SERVICE INFORMATION

APPLICABILITY:	2015MY Legacy & Outback Models with 3.6L Engine	NUMBER:	02-158-14R
SUBJECT:	Accessory Drive Belt Tensioner Component	DATE:	11/21/14
	Changes	REVISED:	01/09/15

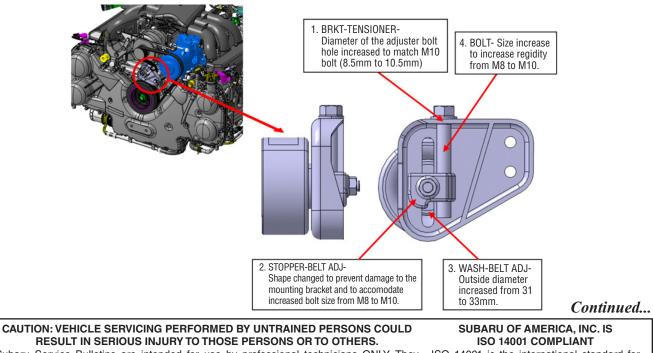
This Service Information bulletin announces changes to the component parts of the accessory drive belt tensioner assembly used on 3.6L H-6 engines. These design changes will increase the rigidity of the tensioner assembly while improving production efficiency.

****VERY IMPORTANT:** If any of the four belt tensioner components described in this bulletin require replacement, <u>ALL FOUR PARTS MUST BE REPLACED AS A SET</u> as they cannot be mixed and matched.
